Responses to Comments on the Draft EA

On November 18, 2019, the FAA released the Draft Environmental Assessment (EA) for the proposed Las Vegas Metroplex Project for public review and comment. The comment period ran for 64 days and closed on January 21, 2020. The FAA recognizes the importance and value of public input in this process.

Figure 1: GIDGT/RATPK Extended to Blue Diamond Road

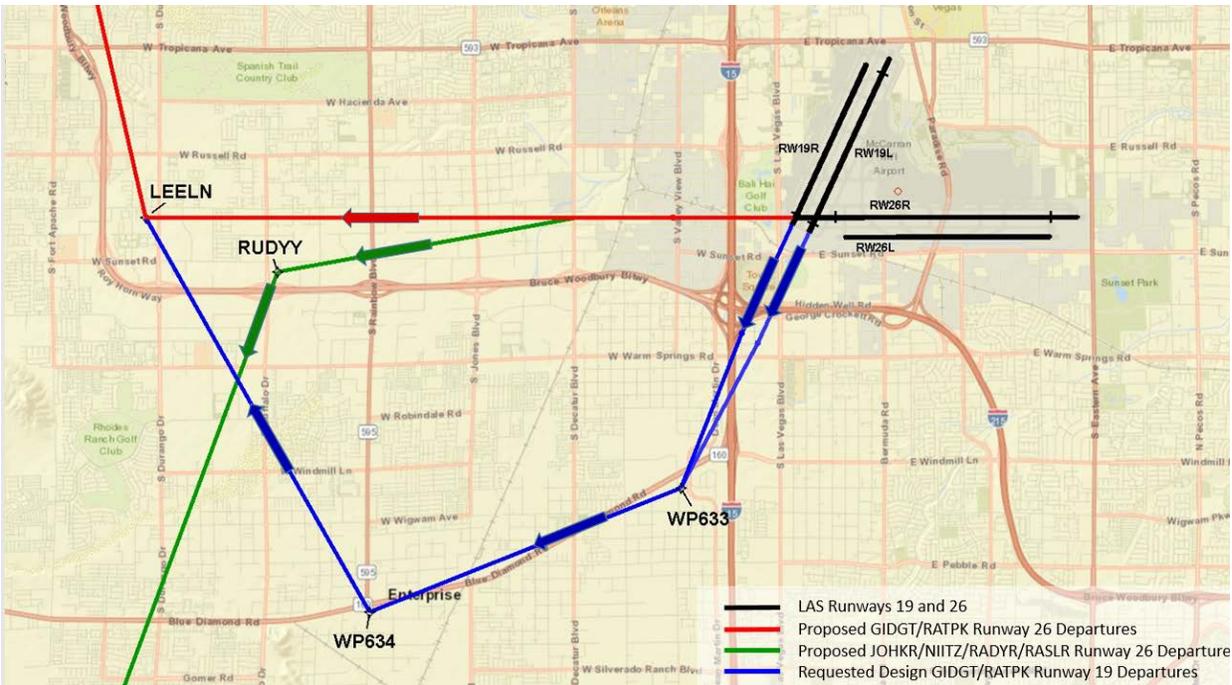
The FAA evaluated a design that delayed making a right turn to LEELN until crossing Blue Diamond Road (approximately 2.5 miles southwest of LAS) (See Figure 1).

The FAA determined that in addition to the criteria failures, the suggested route over Blue Diamond Road would reduce efficiency due to increased delays for departures from separate runways and increase miles flown. Also, extension of the RATPK and GIDGT departure procedures could present a situation where LAS Runway 19 departures would be routed nearly head on toward aircraft on LAS JOHKR, NIITZ, RASLR and RAYDR departure procedures departing LAS Runway 26 (See Figure 1).

Figure 1: GIDGT/RATPK Extended to Blue Diamond Road

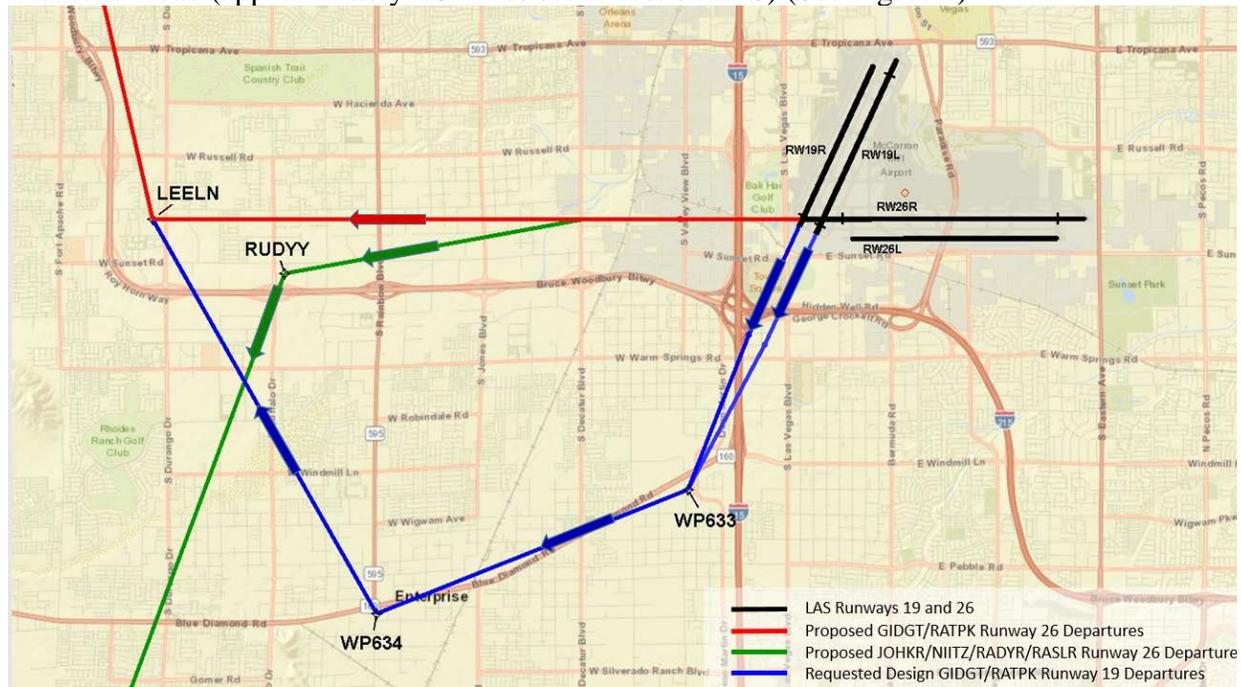
The FAA evaluated a design that delayed making a right turn to LEELN until crossing Blue Diamond Road (approximately 2.5 miles southwest of LAS) (See Figure 1).

The FAA determined that in addition to the criteria failures, the suggested route over Blue Diamond Road would reduce efficiency due to increased delays for departures from separate runways and increase miles flown. Also, extension of the RATPK and GIDGT departure procedures could present a situation where LAS Runway 19 departures would be routed nearly head on toward aircraft on LAS JOHKR, NIITZ, RASLR and RAYDR departure procedures departing LAS Runway 26 (See Figure 1).

Figure 1: GIDGT/RATPK Extended to Blue Diamond Road

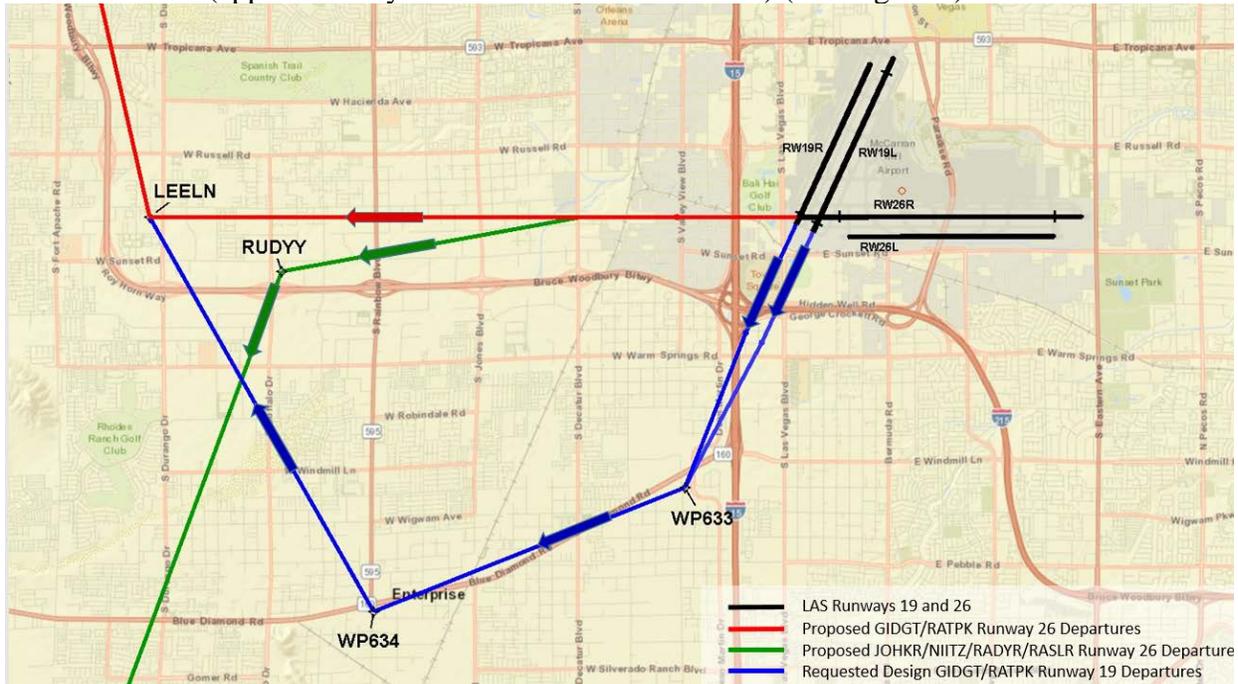
The FAA evaluated a design that delayed making a right turn to LEELN until crossing Blue Diamond Road (approximately 2.5 miles southwest of LAS) (See Figure 1).

The FAA determined that in addition to the criteria failures, the suggested route over Blue Diamond Road would reduce efficiency due to increased delays for departures from separate runways and increase miles flown. Also, extension of the RATPK and GIDGT departure procedures could present a situation where LAS Runway 19 departures would be routed nearly head on toward aircraft on LAS JOHKR, NIITZ, RASLR and RAYDR departure procedures departing LAS Runway 26 (See Figure 1).

Figure 1: GIDGT/RATPK Extended to Blue Diamond Road

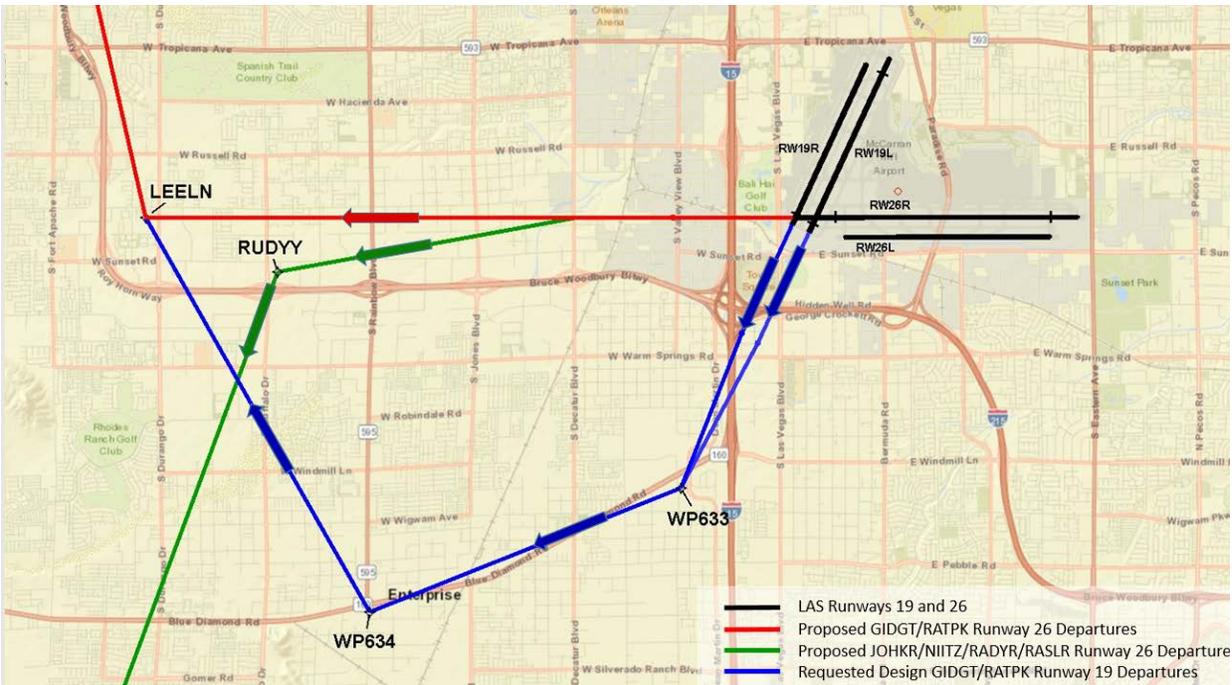
The FAA evaluated a design that delayed making a right turn to LEELN until crossing Blue Diamond Road (approximately 2.5 miles southwest of LAS) (See Figure 1).

The FAA determined that in addition to the criteria failures, the suggested route over Blue Diamond Road would reduce efficiency due to increased delays for departures from separate runways and increase miles flown. Also, extension of the RATPK and GIDGT departure procedures could present a situation where LAS Runway 19 departures would be routed nearly head on toward aircraft on LAS JOHKR, NIITZ, RASLR and RAYDR departure procedures departing LAS Runway 26 (See Figure 1).

Figure 1: GIDGT/RATPK Extended to Blue Diamond Road

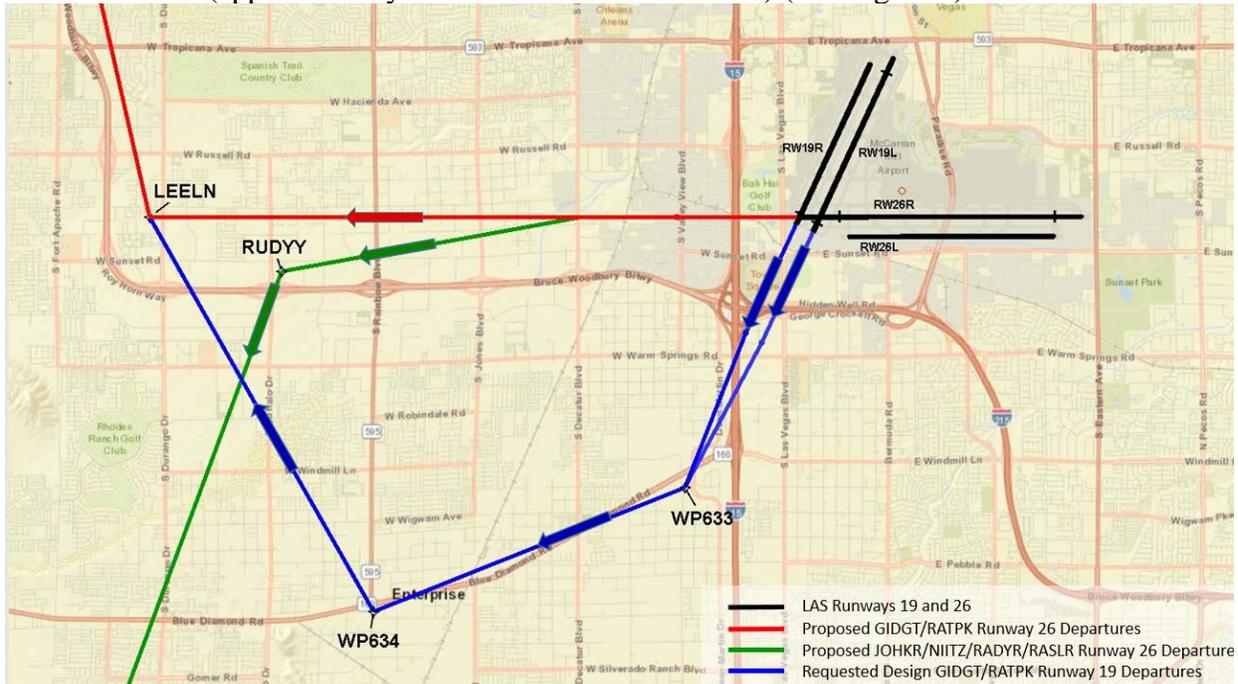
The FAA evaluated a design that delayed making a right turn to LEELN until crossing Blue Diamond Road (approximately 2.5 miles southwest of LAS) (See Figure 1).

The FAA determined that in addition to the criteria failures, the suggested route over Blue Diamond Road would reduce efficiency due to increased delays for departures from separate runways and increase miles flown. Also, extension of the RATPK and GIDGT departure procedures could present a situation where LAS Runway 19 departures would be routed nearly head on toward aircraft on LAS JOHKR, NIITZ, RASLR and RAYDR departure procedures departing LAS Runway 26 (See Figure 1).

Figure 1: GIDGT/RATPK Extended to Blue Diamond Road

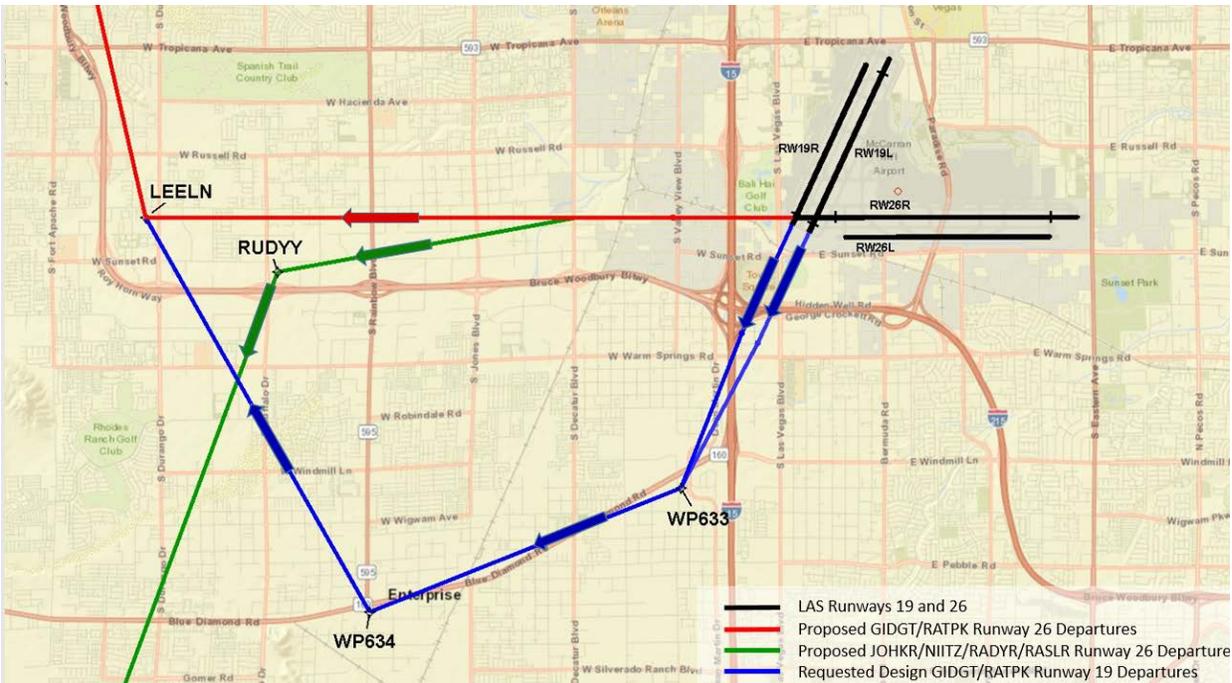
The FAA evaluated a design that delayed making a right turn to LEELN until crossing Blue Diamond Road (approximately 2.5 miles southwest of LAS) (See Figure 1).

The FAA determined that in addition to the criteria failures, the suggested route over Blue Diamond Road would reduce efficiency due to increased delays for departures from separate runways and increase miles flown. Also, extension of the RATPK and GIDGT departure procedures could present a situation where LAS Runway 19 departures would be routed nearly head on toward aircraft on LAS JOHKR, NIITZ, RASLR and RAYDR departure procedures departing LAS Runway 26 (See Figure 1).

Figure 1. Flight Tracks over or near 1L3 at or below 15,000 feet above mean sea level

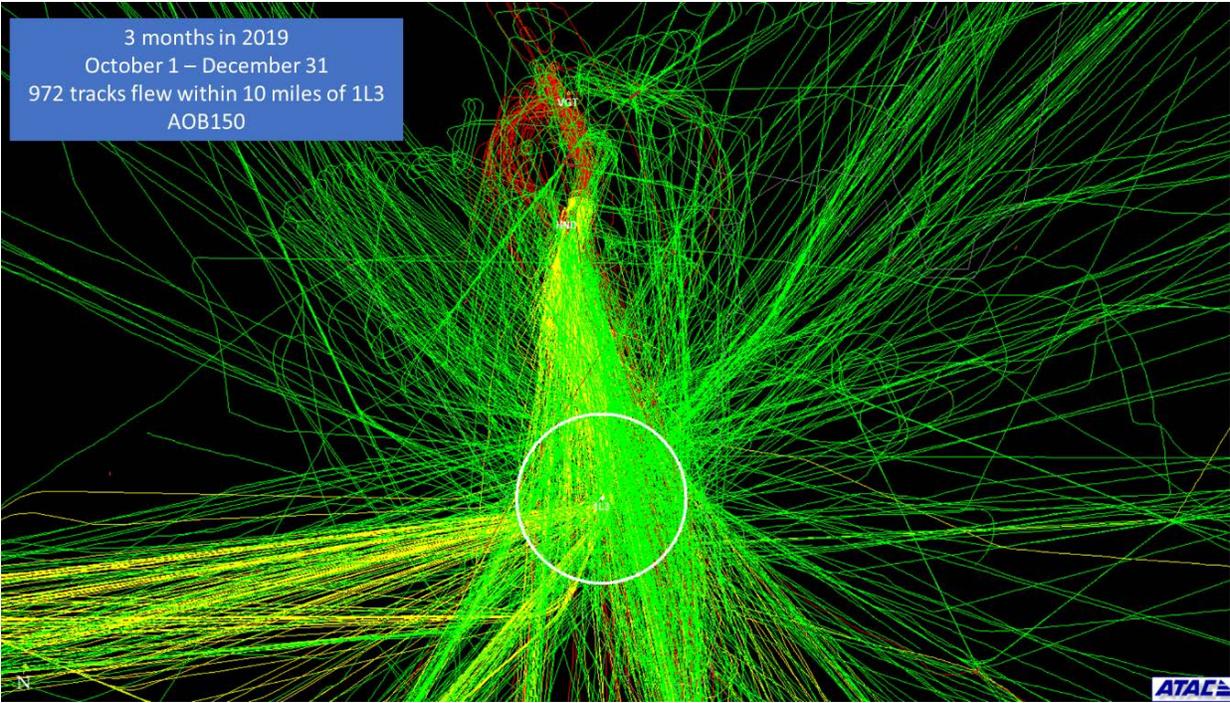
The Federal Aviation Administration (FAA) reviewed historical flight data for the period of October 1, 2019 to December 31, 2019. Using a ten nautical mile diameter circle centered on 1L3, there were a total of 972 flights that entered the defined area at or below 15,000 feet mean sea level, or 11,450 feet above ground level. See **Figure 1**. Of these, 382 landed at either HND or VGT. See **Figure 2**. This number represents only aircraft receiving air traffic control services. There is no way to determine the number of aircraft overflying 1L3 that were not receiving air traffic services.

After review, the FAA determined that the proposed NTNDO arrival procedure could not be moved or eliminated due to safety and efficiency considerations.

Figure 1. Flight Tracks over or near 1L3 at or below 15,000 feet above mean sea level

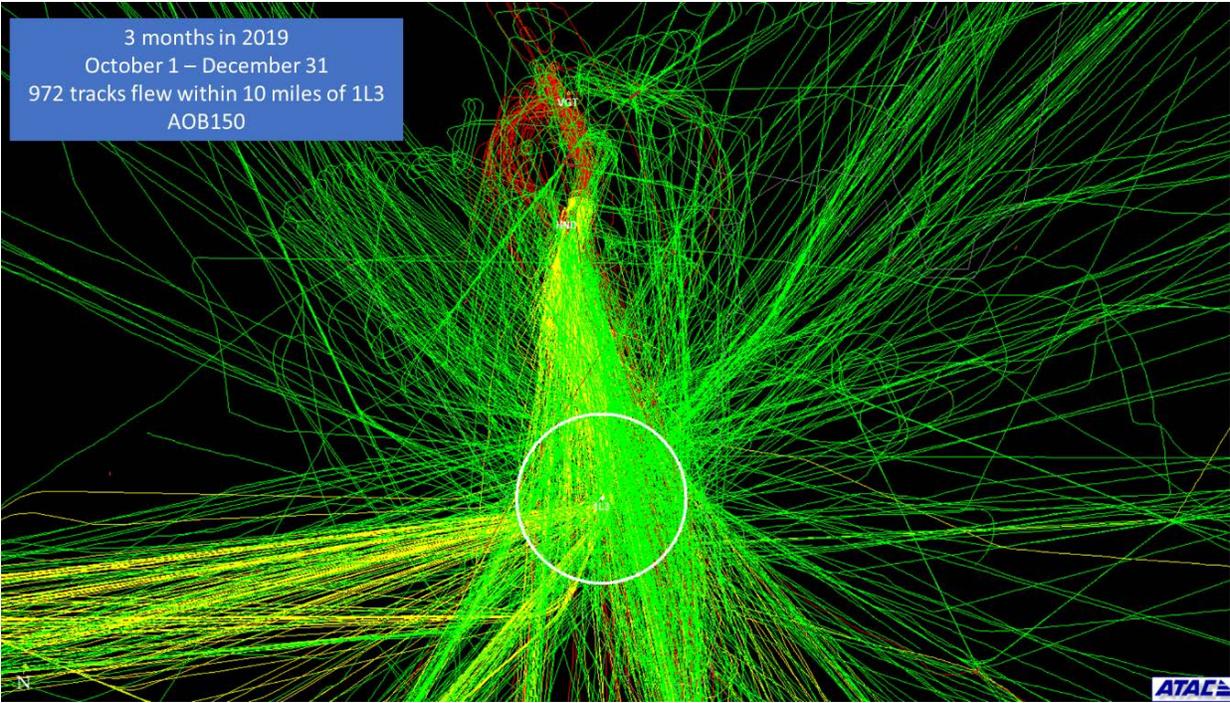
The Federal Aviation Administration (FAA) reviewed historical flight data for the period of October 1, 2019 to December 31, 2019. Using a ten nautical mile diameter circle centered on 1L3, there were a total of 972 flights that entered the defined area at or below 15,000 feet mean sea level, or 11,450 feet above ground level. See **Figure 1**. Of these, 382 landed at either HND or VGT. See **Figure 2**. This number represents only aircraft receiving air traffic control services. There is no way to determine the number of aircraft overflying 1L3 that were not receiving air traffic services.

After review, the FAA determined that the proposed NTNDO arrival procedure could not be moved or eliminated due to safety and efficiency considerations.

Figure 1. Flight Tracks over or near 1L3 at or below 15,000 feet above mean sea level

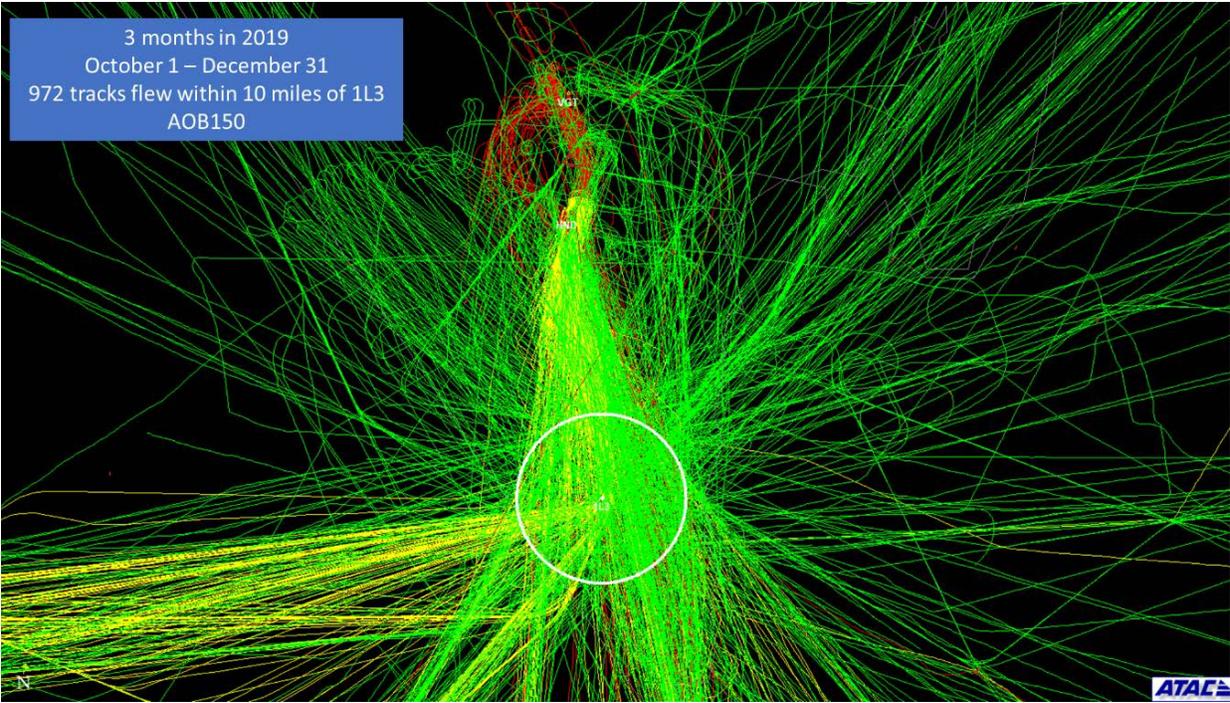
The Federal Aviation Administration (FAA) reviewed historical flight data for the period of October 1, 2019 to December 31, 2019. Using a ten nautical mile diameter circle centered on 1L3, there were a total of 972 flights that entered the defined area at or below 15,000 feet mean sea level, or 11,450 feet above ground level. See **Figure 1**. Of these, 382 landed at either HND or VGT. See **Figure 2**. This number represents only aircraft receiving air traffic control services. There is no way to determine the number of aircraft overflying 1L3 that were not receiving air traffic services.

After review, the FAA determined that the proposed NTNDO arrival procedure could not be moved or eliminated due to safety and efficiency considerations.

Figure 1: GIDGT/RATPK Extended to Blue Diamond Road

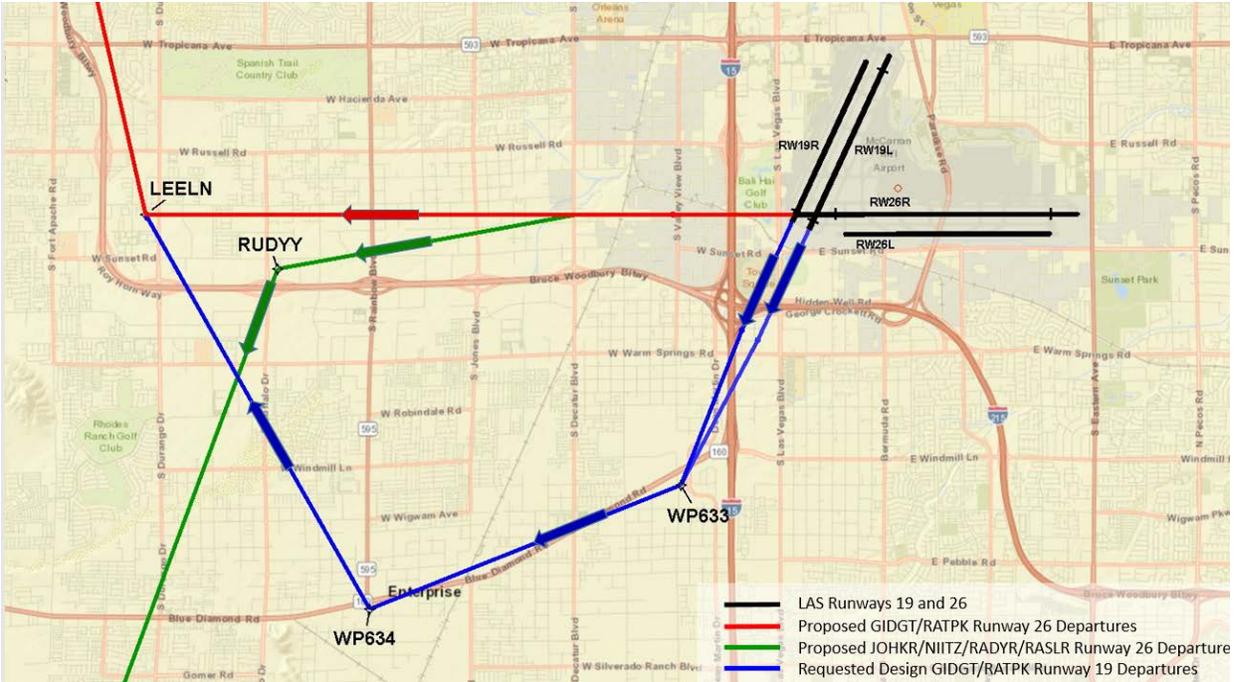
The FAA evaluated a design that delayed making a right turn to LEELN until crossing Blue Diamond Road (approximately 2.5 miles southwest of LAS) (See Figure 1).

The FAA determined that in addition to the criteria failures, the suggested route over Blue Diamond Road would reduce efficiency due to increased delays for departures from separate runways and increase miles flown. Also, extension of the RATPK and GIDGT departure procedures could present a situation where LAS Runway 19 departures would be routed nearly head on toward aircraft on LAS JOHKR, NIITZ, RASLR and RAYDR departure procedures departing LAS Runway 26 (See Figure 1).
